E5515C-14

S E R V I C E N O T E

E5515C Wireless Communications Test Set (8960 Series)

2 Missing Washers on the DSP Fan Assembly Requires Replacement of the 5.8 DSP Board

Figure 1: Washer locations

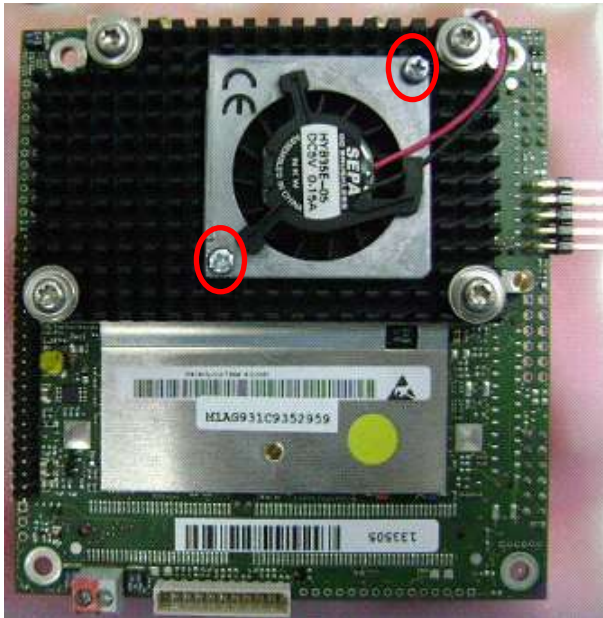
All 5.8 Hardware DSPs, part number E5515-60576, within the serial number range above need to be inspected for 2 missing washers on the DSP fan assembly (detailed pictures are below). If the washers are missing then the 5.8 DSP will need to be replaced with the repair kit E5515-61845.

The two washers are located on the DSP fan assembly as shown in the picture below. The washer sits in between the screw head and fan assembly metal work.

If the 5.8 DSP fan does not have the washers, replace the DSP Assembly using the repair kit E5515-61845. Verify that the test set boots up and operates normally. Re-calibration is not required.

Figure 3: Washer Missing

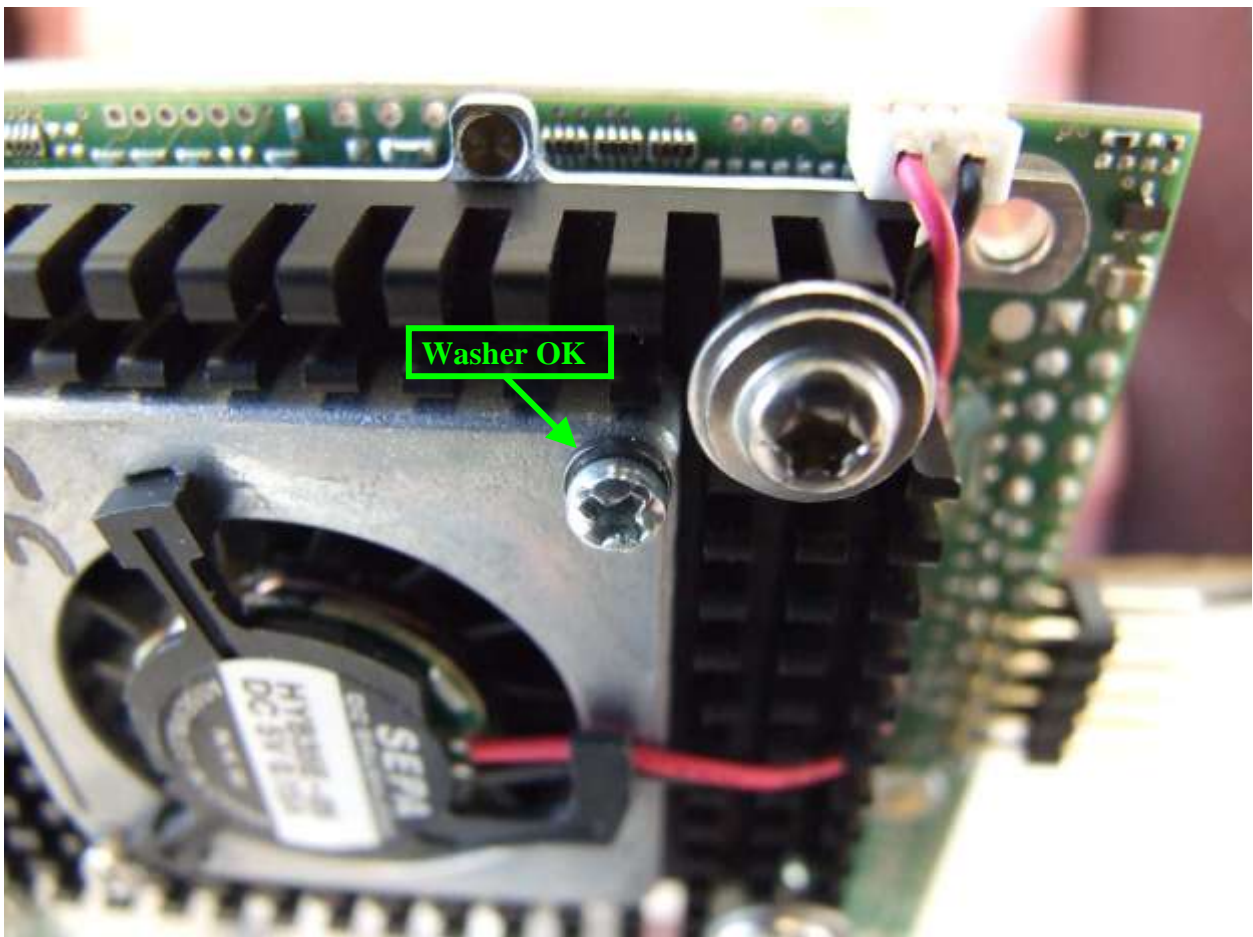
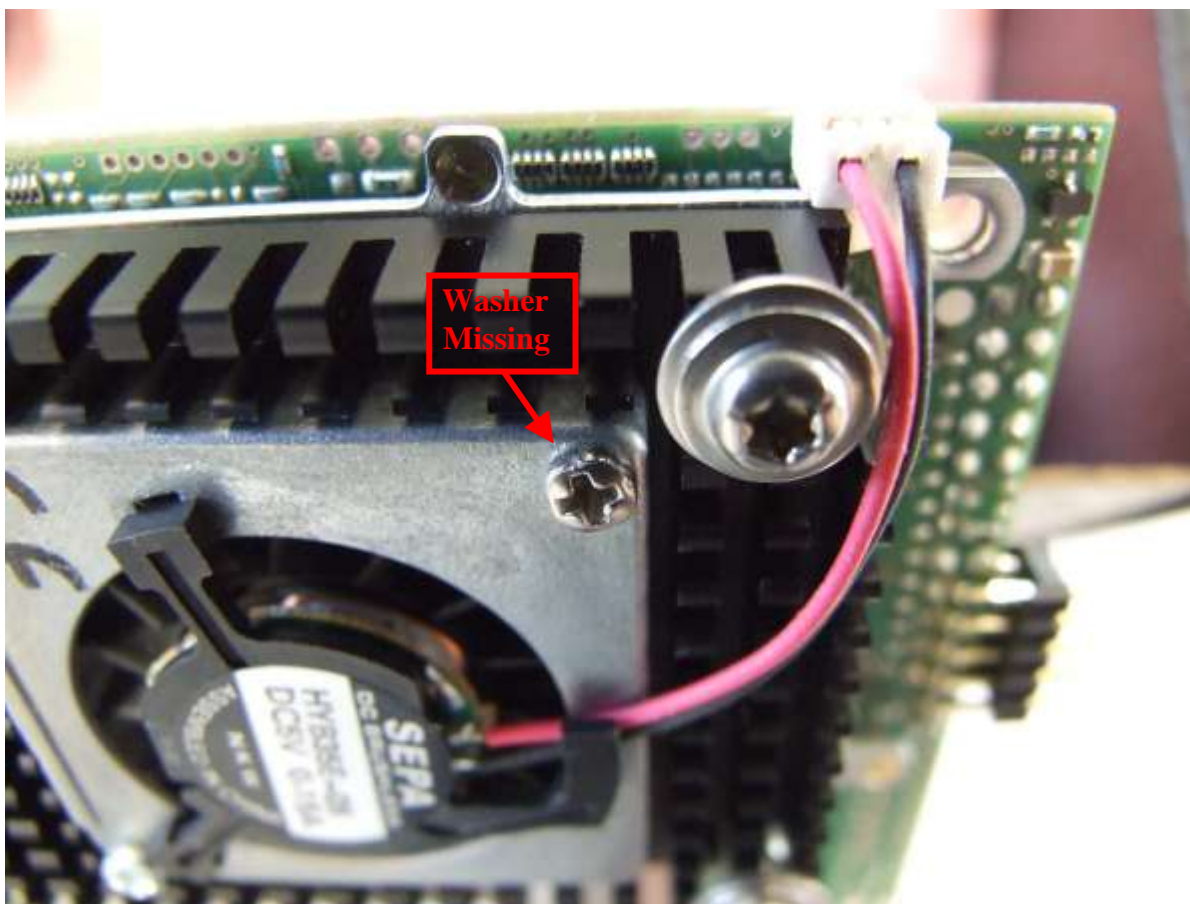
Without the washers, the screws bottom out and lift the heat sink from the sheet metal below, causing an air gap, less cooling effect and therefore a hotter running DSP which will eventually fail.
